KCK COMMUNITY EDUCATION, HEALTH & WELLNESS CENTER

ADDENDUM #1

PGAV PROJECT #53664-00

April 15, 2024

REVISED ELECTRICAL DESIGN

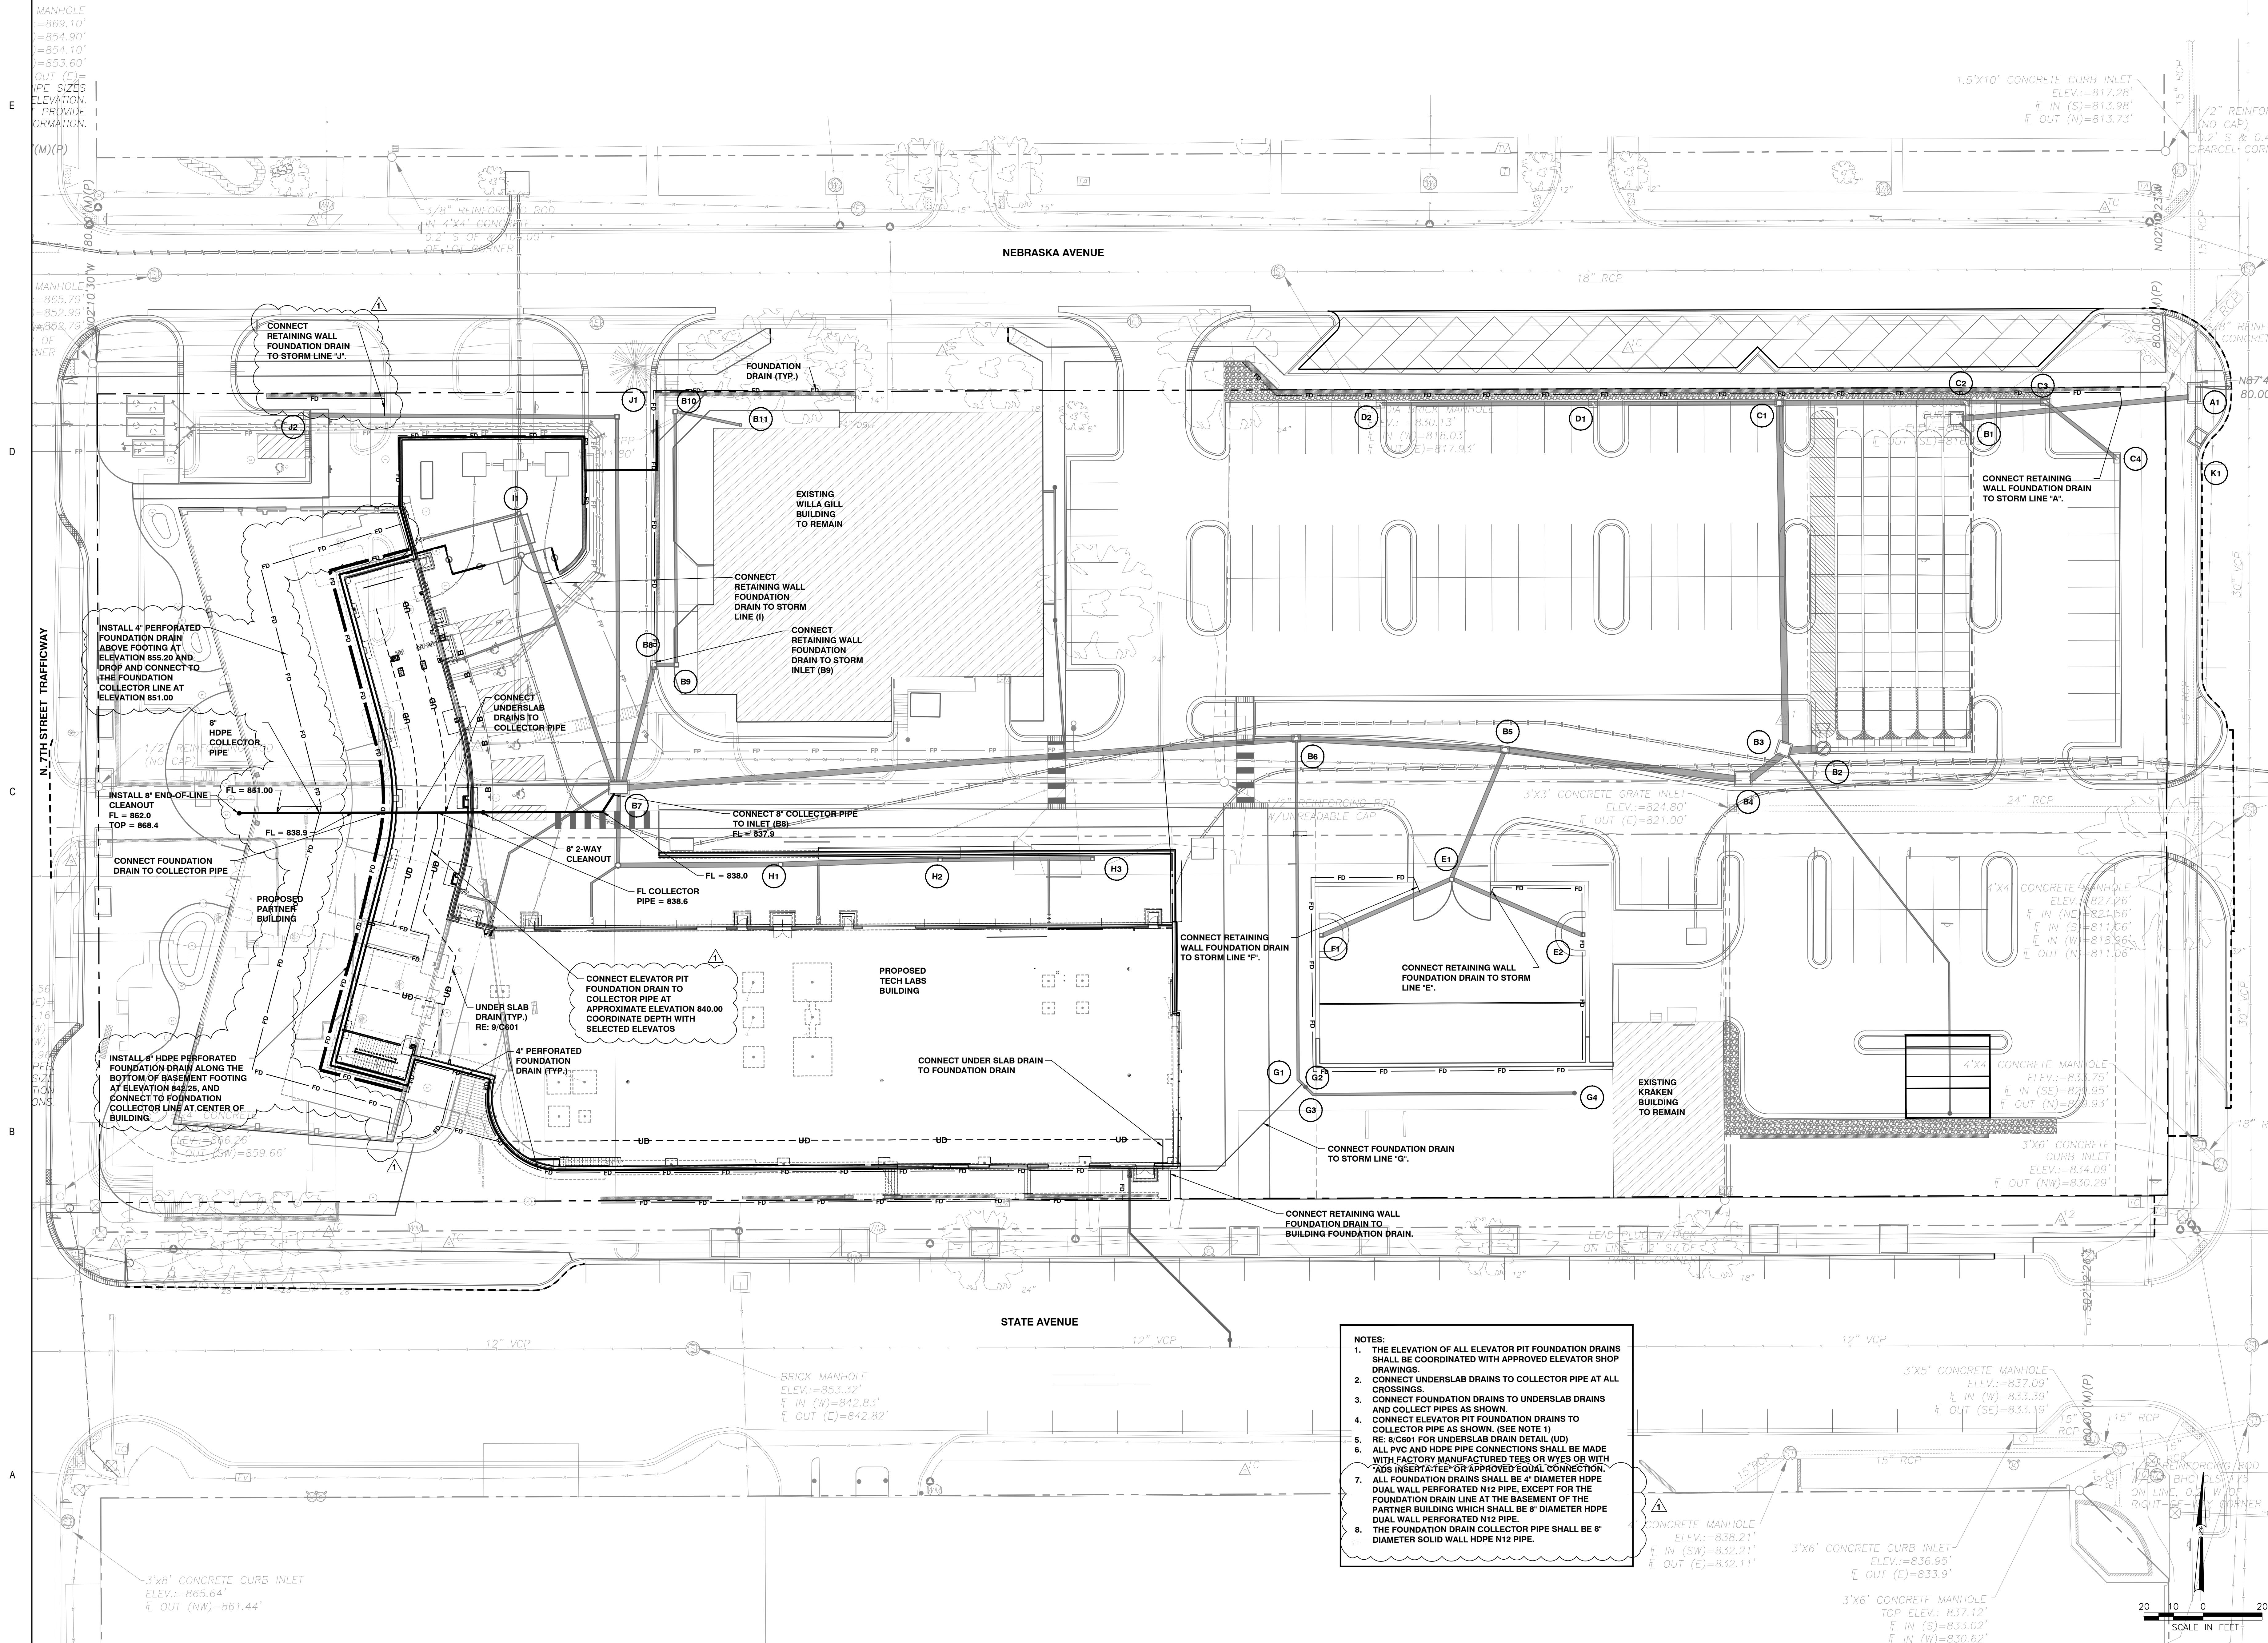
- 3.7 C510 – Utilities Plan**
 1. Refer to the attached revised sheet with revisions dated 4/15/2024:
 - a. Revised electrical design.
 - b. Added roof drain line from ATM.

LEVEL 2 FOUNDATION & FRAMING PLAN AREA "A"
1/8" = 1'-0"

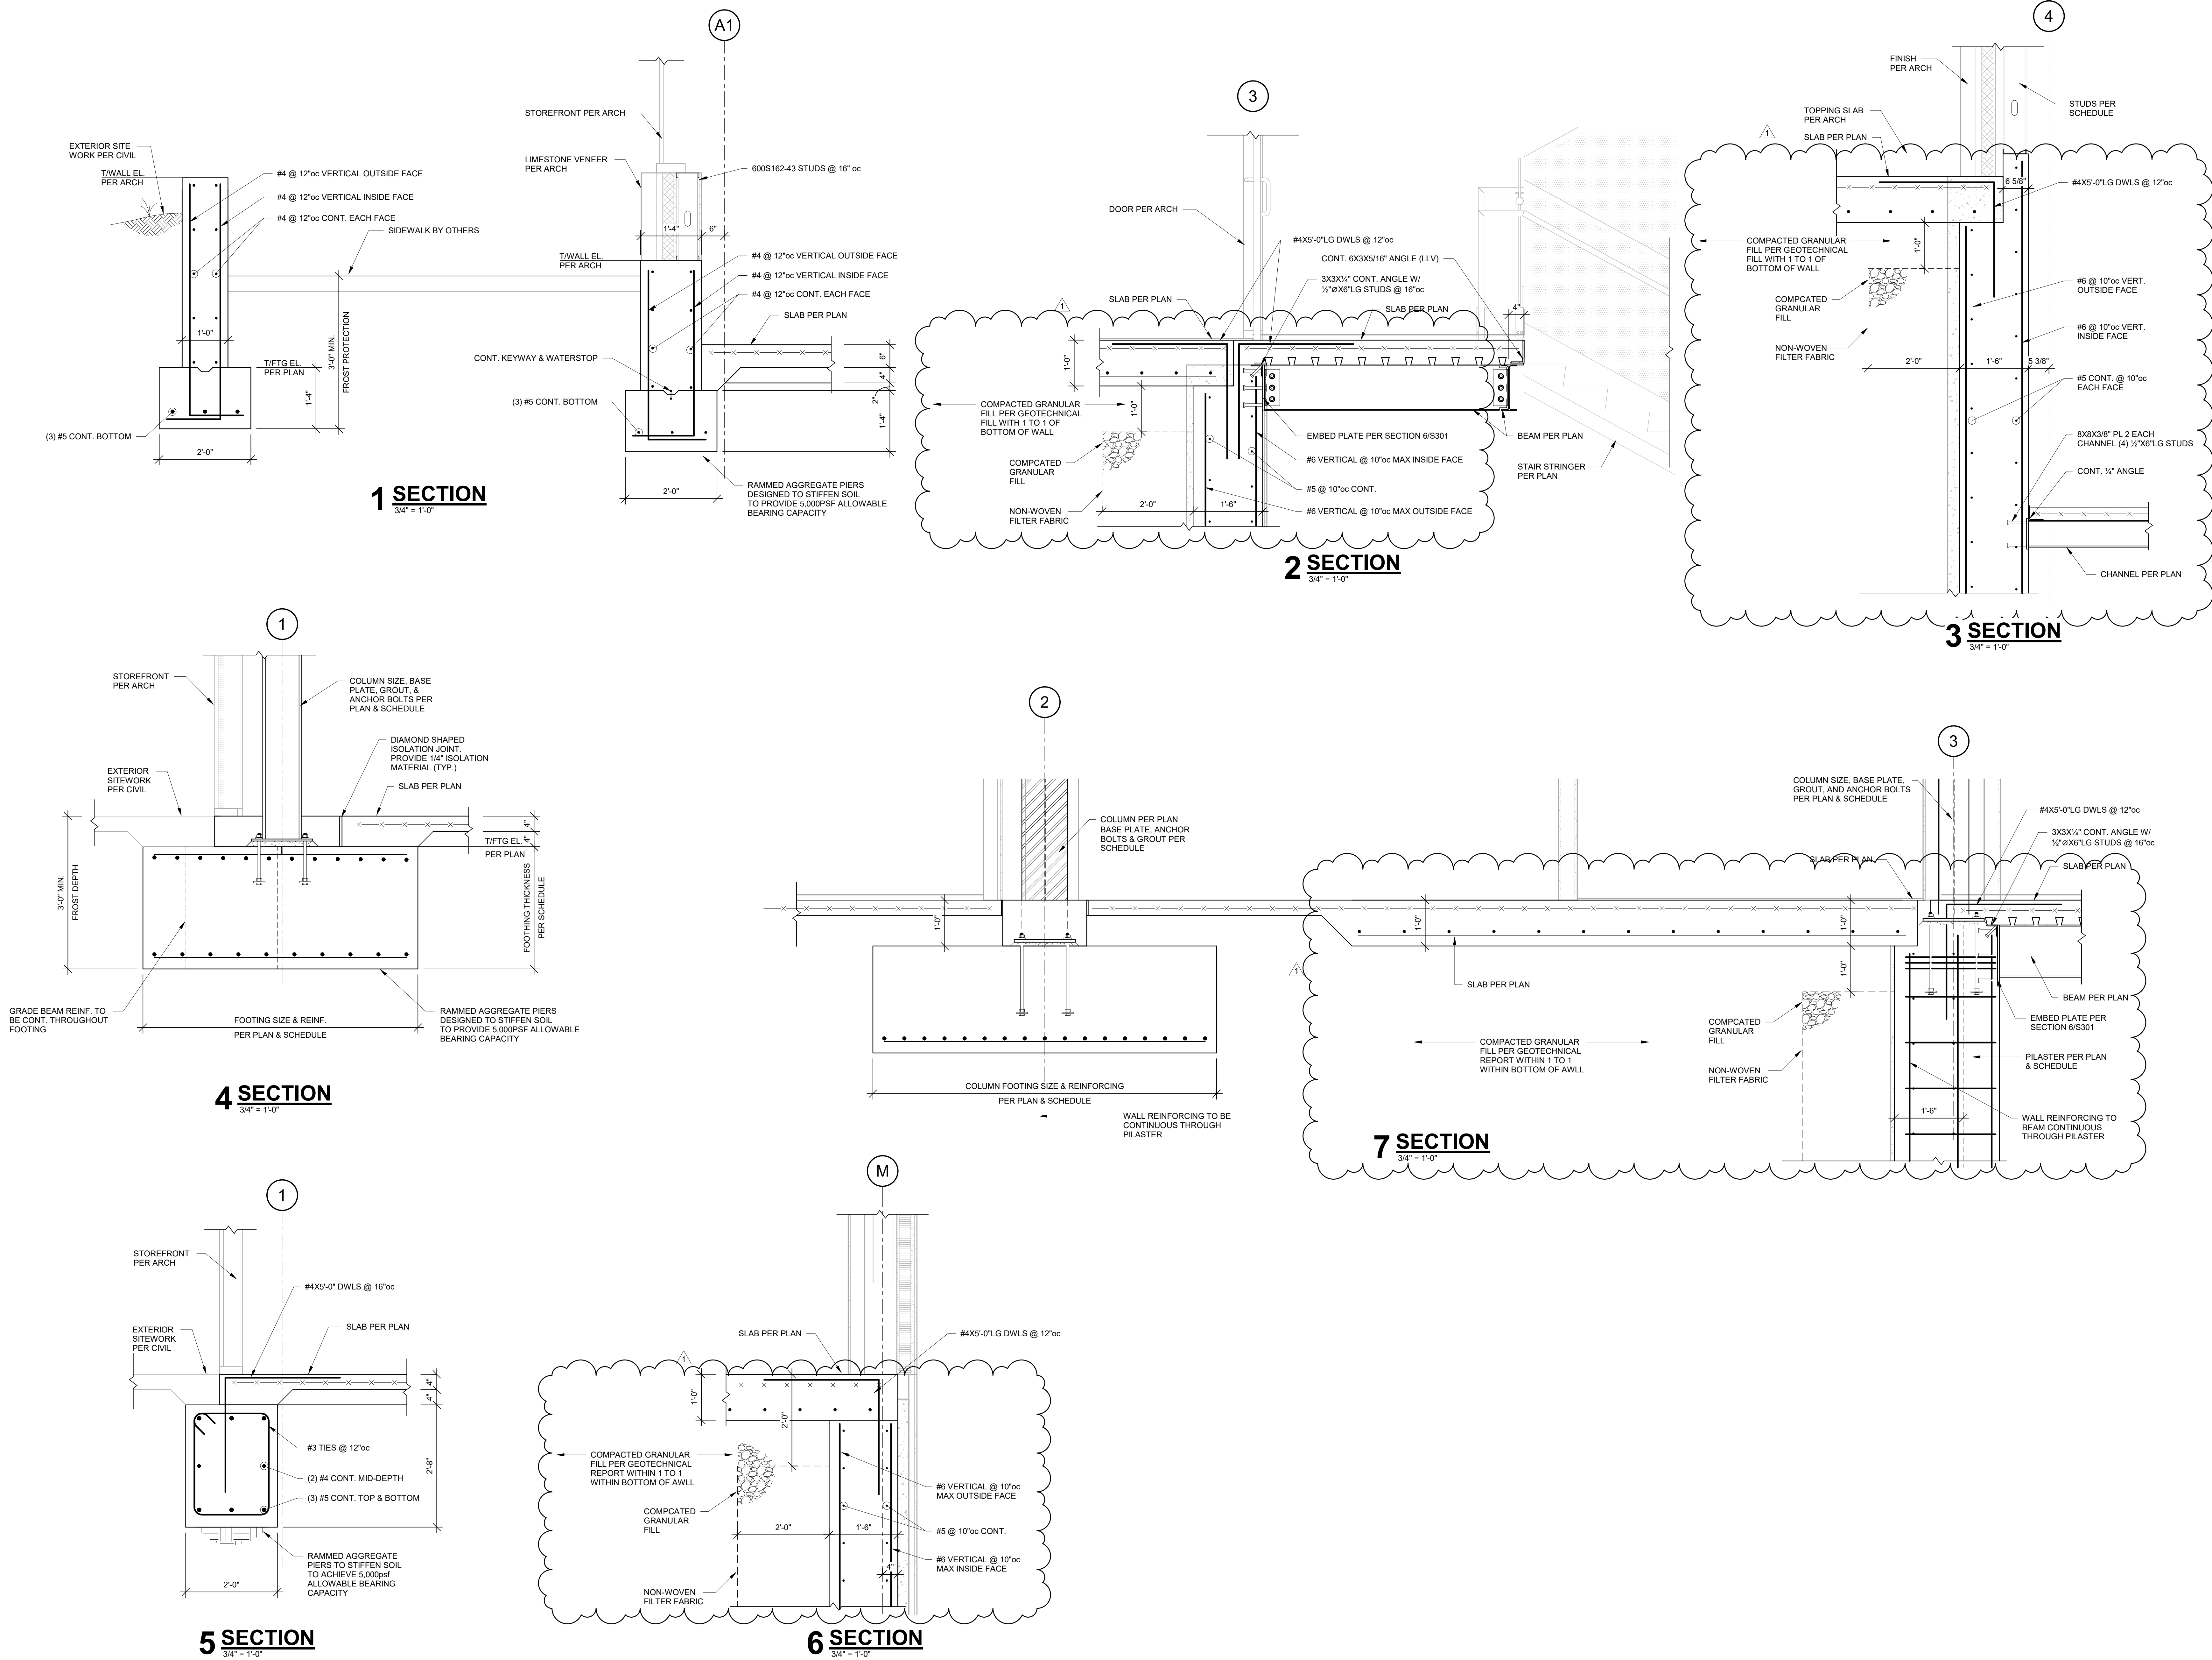
- 3.13 S101A – Level 2 Foundation & Framing Plan – Area “A”**
 1. Refer to the attached revised sheet with revisions dated 4/15/2024:
 - a. Revised basement foundation wall, footings, and slab.

- b. Added note for surveying of foundation wall and steel coordination.
- 3.14 S201 – Foundation Sections**
